# MIAMI BEACH

### Staff Memorandum

### Historic Preservation Board

SUBJECT: HPB17-0142, **1600 Washington Avenue, 425 16<sup>th</sup> Street & 1601 Drexel Avenue.**

#### **1600 Washington Avenue – request for total demolition**

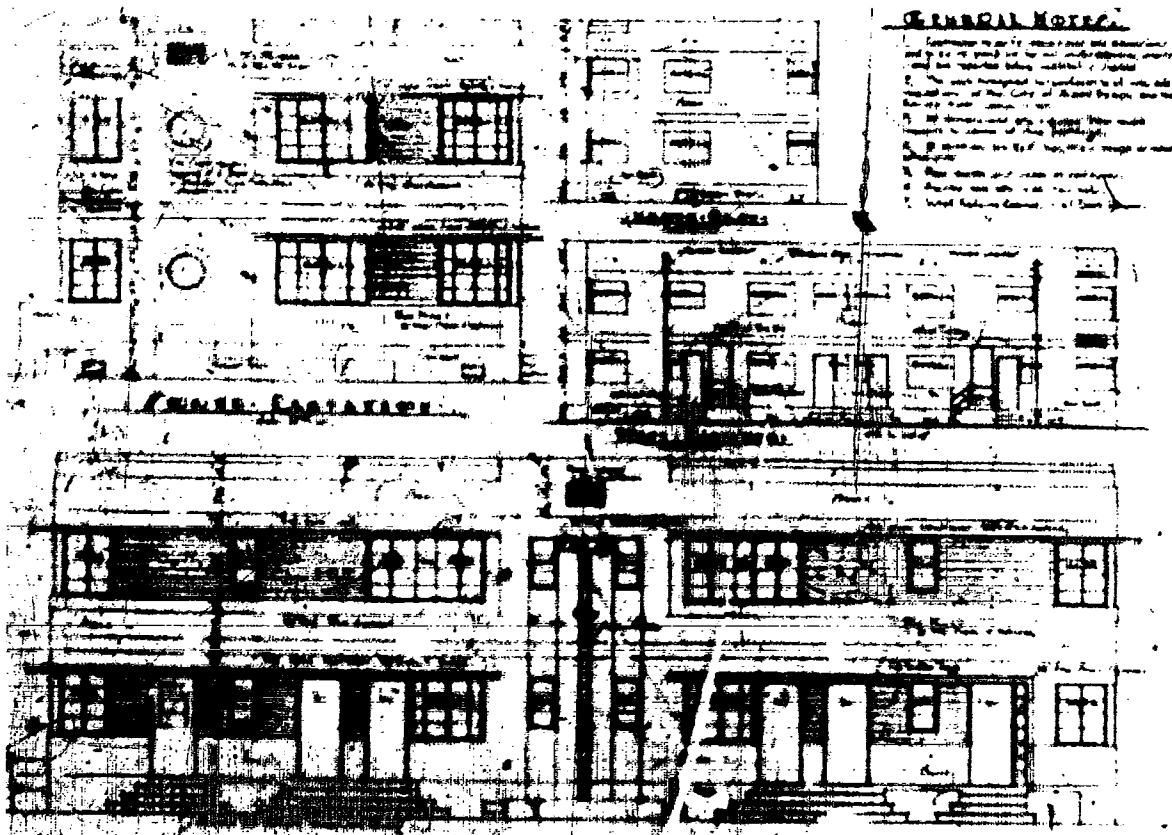
The 1-story building located at 1600 Washington Avenue was constructed in 1952 and designed by architect Maurice Weintraub. Due to significant alterations that have occurred over the years, the subject structure is classified as Non-Contributing. Since the existing building retains little to no original architectural elements, staff has no objection to the applicant's request for total demolition of this structure.
